APPLICATION FOR PERMIT TO DRILL OR REENTER

1a. Type of work: <input checked="" type="checkbox"/> DRILL <input type="checkbox"/> REENTER		7. If Unit or CA Agreement, Name and No.
1b. Type of Well: <input checked="" type="checkbox"/> Oil Well <input type="checkbox"/> Gas Well <input type="checkbox"/> Other <input checked="" type="checkbox"/> Single Zone <input type="checkbox"/> Multiple Zone		8. Lease Name and Well No. <i>ADCode</i> MISTY 35 FEDERAL COM #4H (39934)

RE: Misty 35 Federal Com #4H
Section 35, 18S-30E
Eddy County, New Mexico

WELL LOCATION AND ACREAGE DEDICATION PLAT

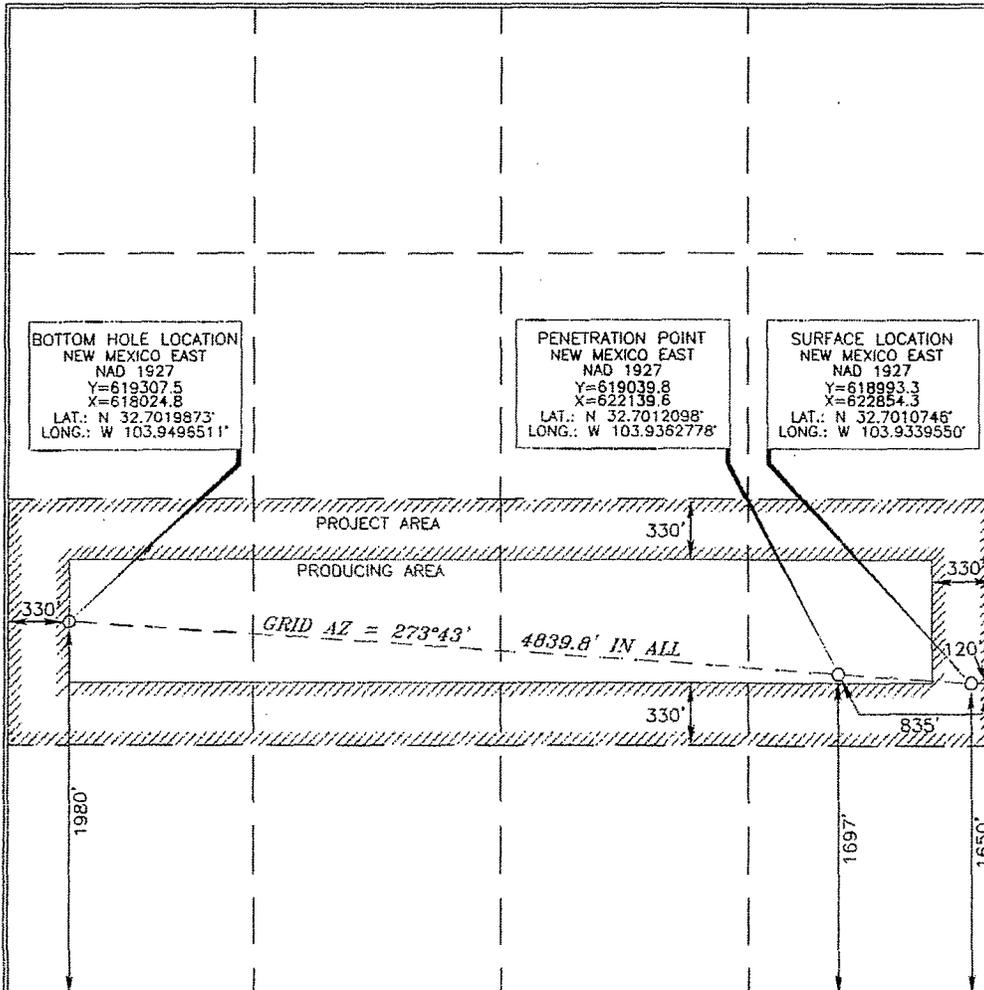
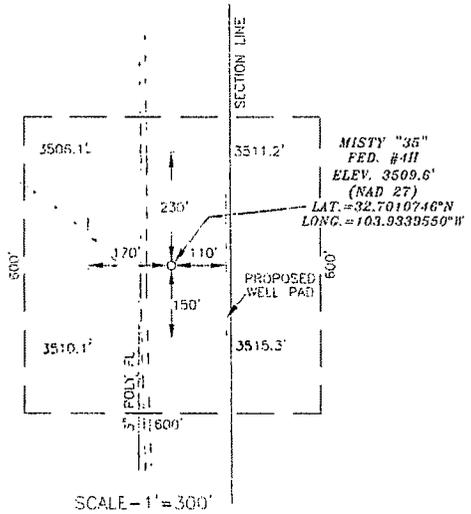
3. The survey plat does not match the dimensions of the pad described in the surface use plan, #9. The survey does not match the rig layout diagram dimensions. Either a new onsite with a new survey will need to be conducted or you will need to let me know that it is OK to change the dimensions on the diagrams.
